Intel[®] Pentium[®] III Xeon[™] Processor Specification Update

Release Date: November 2001

Order Number: 244460-031

The Pentium[®] III Xeon[™] processor may contain design defects or errors known as errata that may cause the product to deviate from published specifications. Current characterized errata are documented in this Specification Update.

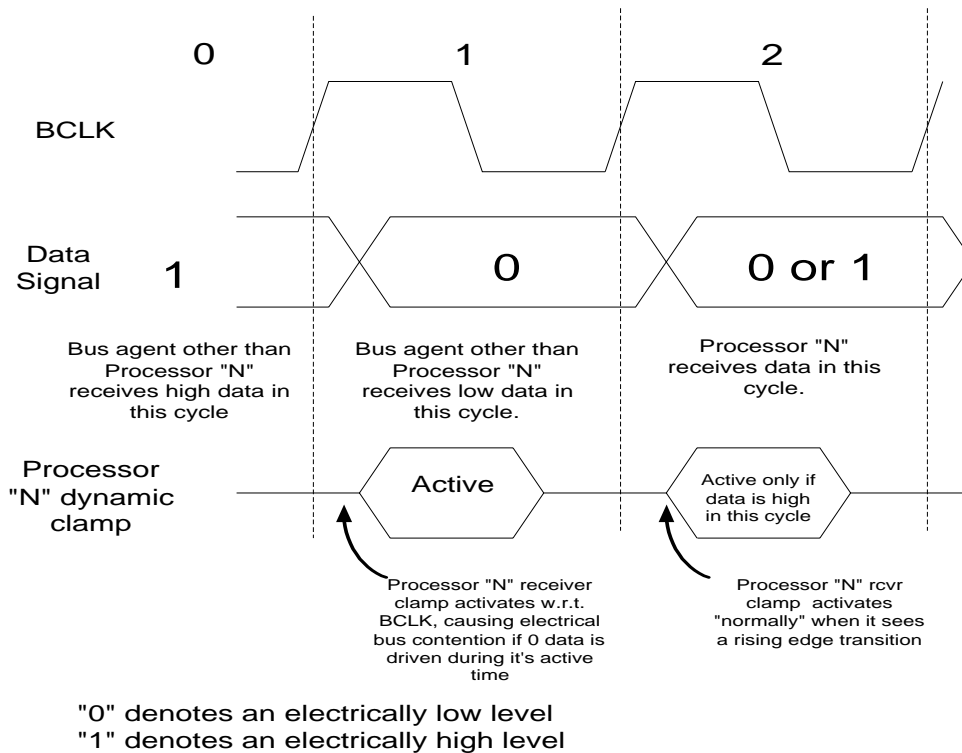
Workaround: The AGTL+ V_{REF} (input voltage reference) level will be raised from 1.0V to 1.1V (assuming a V_{TT} of 1.5V) on the processor cartridge substrate. This allows the dynamic clamp to activate at a trigger level approximately 100 mV higher than with the previous 1.0V V_{REF} setting. Due to the dependence upon system bus design, bus layout may be evaluated to determine the need for improvements in falling edge ringback levels. This may involve one or several of the following baseboard modifications:

1. Change termination resistor value to reduce multi-bit noise and/or improve V_{IL} noise margin.
2. Reduce multi-bit noise by improving ground return paths (additional high-frequency decoupling, improved AC plane referencing, etc.).
3. Raising or lowering the V_{TT} level (within the AC & DC tolerances specified in the processor EMTS) to improve V_{IL} noise margin and/or reduce the multi-bit noise due to dl/dt transients.

Stress tests using various data patterns and transactions should be run to identify the worst-case multi-bit noise conditions for this erratum.
